URETHANE PAD BOLTS BREAKING

The MVC88 plate compactor has an optional urethane pad that may be mounted to the bottom of the plate. The optional pad comes in a kit. It has been noted that the urethane pad mounting bolts may break in the event you have installed the incorrect installation kit.

Interlocking Bolt

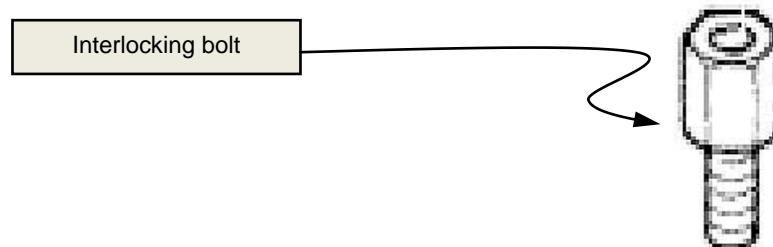
The difference in the two kits is the size of the INTERLOCKING BOLT. One is longer to make up for the difference in the height of the vibrator housing assembly.

There was a production change and the vibrator housing assembly was increased.

- UPA-88 Kit contains interlocking bolt size 16 X 35
- UPA-88A Kit contains interlocking bolt size 16 X 40

- **S/N K6886** and below uses kit number: **UPA-88**
- **S/N K6887** and above uses kit number: **UPA-88A**

- H = 7/16" (11mm) for serial numbers up to K6886
- H = 9/16" (14mm) for serial numbers after K6887
